HISTORIC PRESERVATION COMMISSION STAFF REPORT

Address:	3807 Williams Lane, Chevy Chase	Meeting Date:	07/13/05
Applicant:	Timothy and Kathy Lynch	Report Date:	07/06/05
Resource:	Master Plan Site # 35/77 Frank Simpson House	Public Notice:	06/29/05
Review:	Preliminary Consultation #2	Tax Credit:	N/A
PROPOSAL:	New Guest House Construction	Staff:	Michele Oaks
RECOMMEND:	Proceed to HAWP <i>w/ tree protection plan</i>

Lynch Guest Home

Lynch Residence Guest House

Site Plan

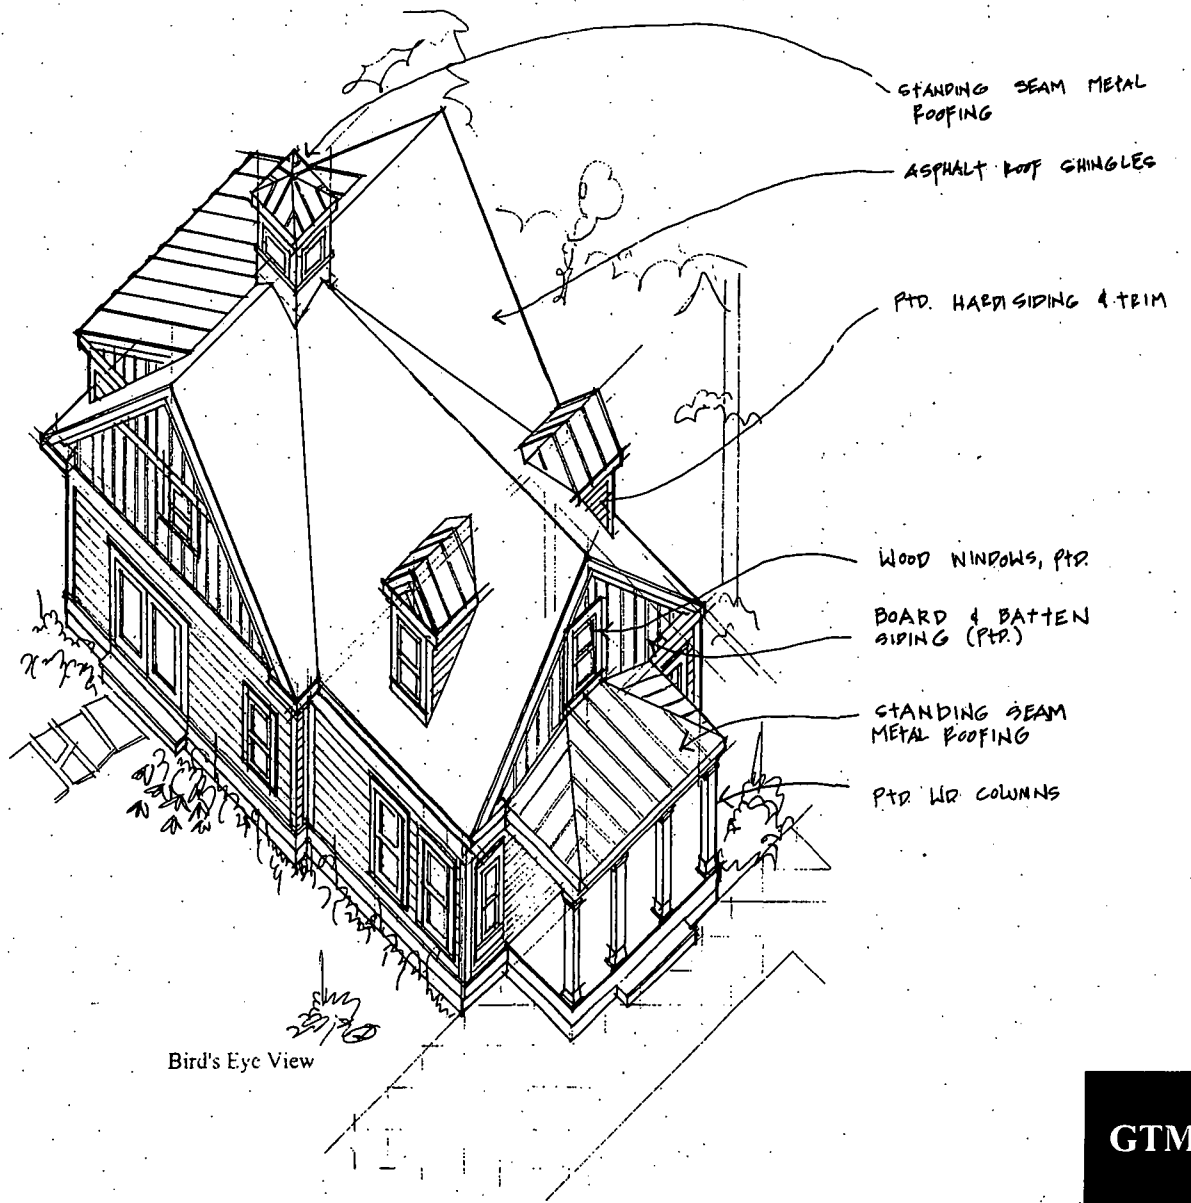
7 The site plan that I gave you is an update,
8 because the staff mentioned that the building would be 20
9 feet from the back of the building. That's not accurate.
10 It would actually, from the two main structures, it would be
11 actually 37 and a half feet. There is a deck, but that's a
12 one-story deck. And there is a small porch on the front of
13 our carriage house, which again, is probably not supported
14 as interior space.

Proposed Yard Side & Front Elevations

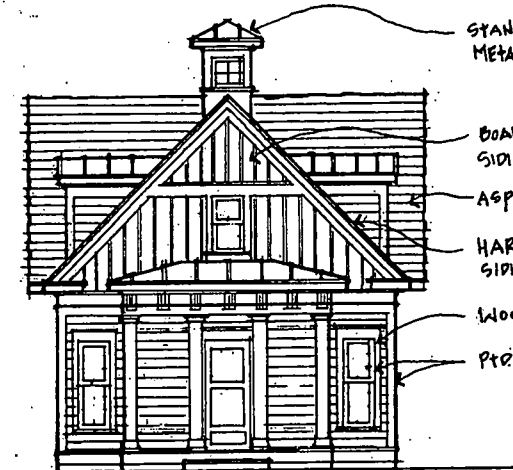
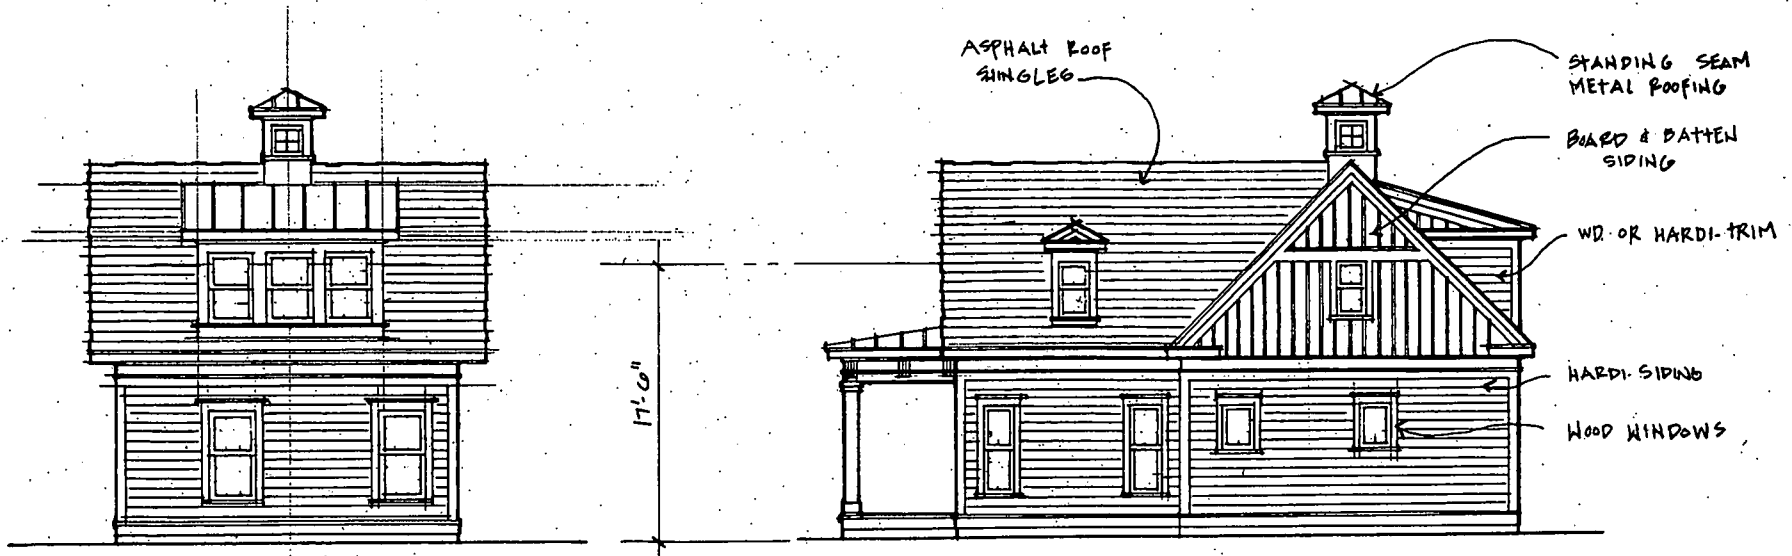
17 MR. BRESLIN: For instance, you look down the
18 driveway and you see four nice columns and a beautiful front
19 porch.

21 MR. BRESLIN: No, but which reads as house --

23 MR. BRESLIN: -- as opposed to reading as
24 outbuilding. But I think it is elements like that, and I
25 personally think it's the size. I think with this size,

Proposed First & Second Floor Plan

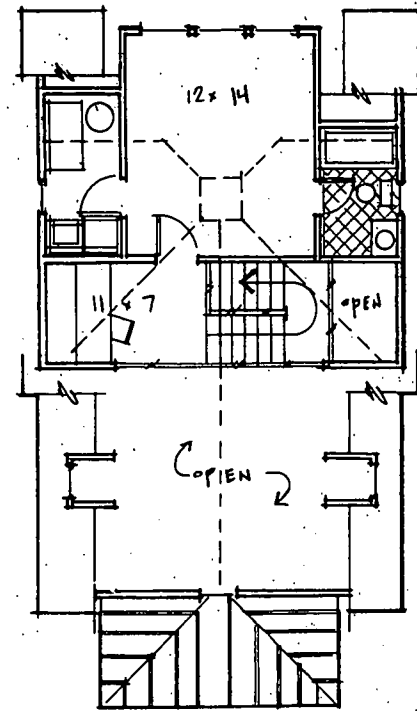
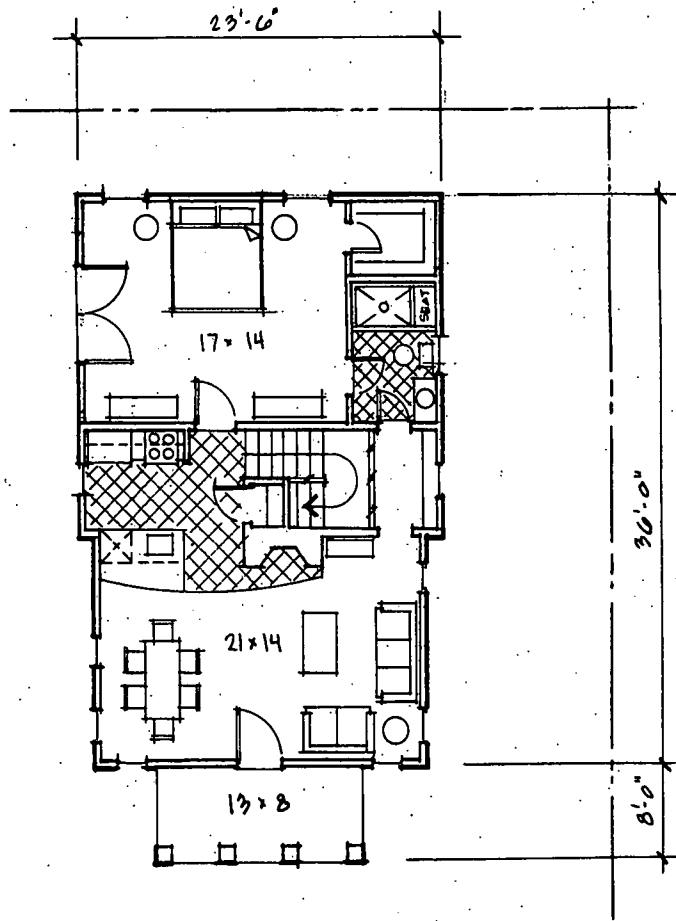
21 MS. WRIGHT: Actually, that's circle 17. Or
22 circle 15 actually comes close to that, if you assume that
23 you didn't do the front porch on circle 15.

1 porch as enclosed space, and extend your kitchen into that,
2 and extend the bedroom into that, you could get a two-
3 bedroom structure in 20 by 28.

21 MS. WRIGHT: I mean, I really think, again, you
22 know, looking at circle 15, that with some tweaking, again,
23 don't look at the picture of the building, just look at the
24 floor plan, that you could probably get your program in,
25 eliminating the front porch which is something that was 20

1 by 28, and still have two bedrooms.
